Access Compliance Report

Public Rights-of-Way

(Pedestrian Signals)

Intersection ID: N/A	Main Street:	Cross Street: N/A	Location: N/A
ADA ID: 0C0547DED927	Signal Type: Two Push Buttons-APS	Overall Compliance: No	Severity Score: BTN 1:N/A BTN 2: N/A No BTN: N/A
Codes/Mitigation Info/Possible Solution		Field Measurements/Component Compliance

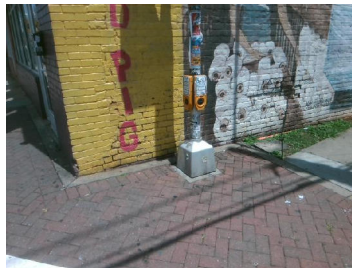
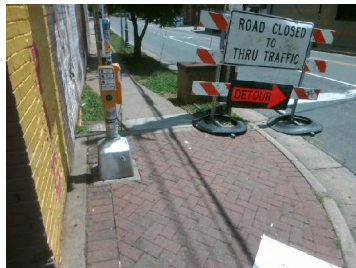
Surveyor Notes: TEXT HT 3/8

PROW/ADA: R410.6, TMUTCD 4e.08, R404.2, R406.2, R104.2, R209.1, , R404.3

Yes	B 1 Clear Xing Direction?	ClearlyMarked	Yes	B 2 Clear Xing Direction?	ClearlyMarked
	B 1 Crossing Direction	To SW		B 2 Crossing Direction	To SE
Yes	B 1 DistanceTo XWalk (in)	0.0	Yes	B 2 DistanceTo XWalk (in)	30.0
No	B 1 DistanceTo Curb (in)	84.0	No	B 2 DistanceTo Curb (in)	89.0
Yes	B 1 Diameter (in)	2.0	Yes	B 2 Diameter (in)	2.0

Possible Solutions: Replace Signal Push Button With APS Button on New Post. Remove & Replace Sign.
